ADDENDUM 4
BID PROPOSAL NO. 1138
EMERGENCY EGRESS LIGHTING MODIFICATIONS – BOYCE CAMPUS
APRIL 4, 2025

CCAC BOYCE CAMPUS
EGRESS LIGHTING MODIFICATIONS

E6.1 SK2

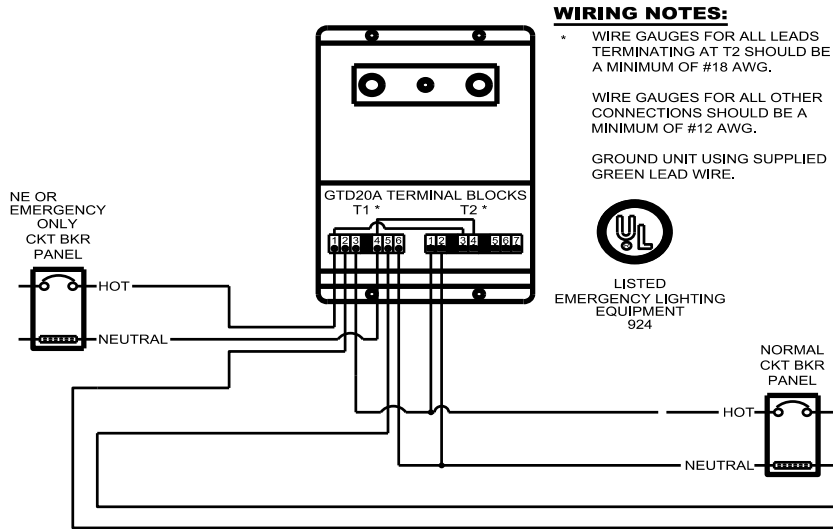
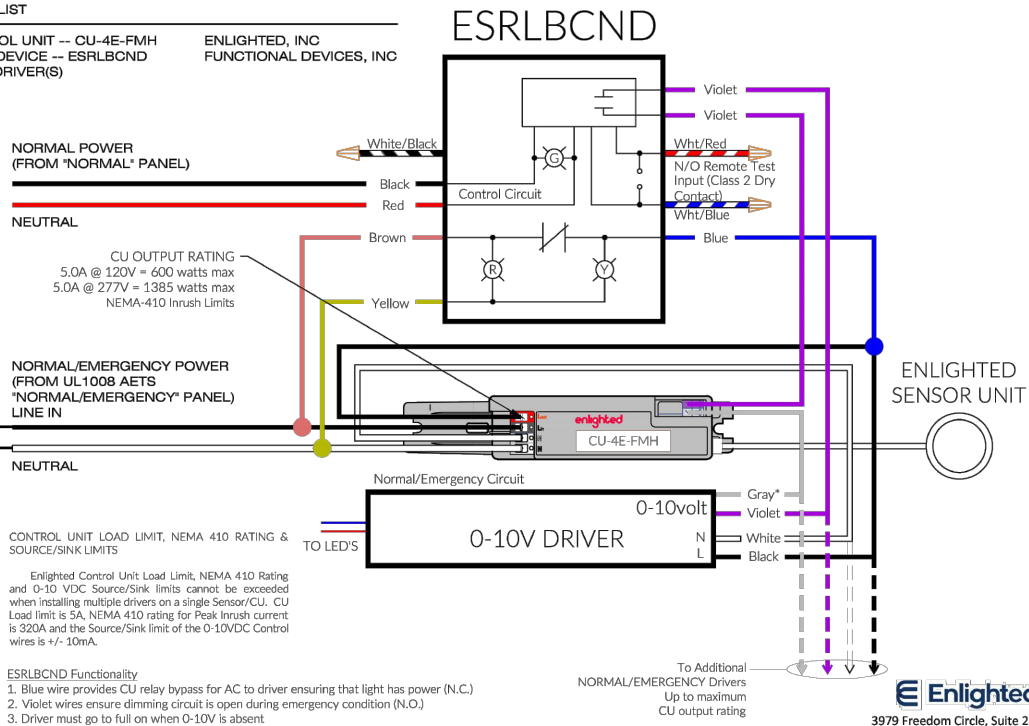
NOTE:

PROVIDE EACH FIXTURE ON EGRESS CIRCUITS WITH AN ESRLBCND DEVICE.
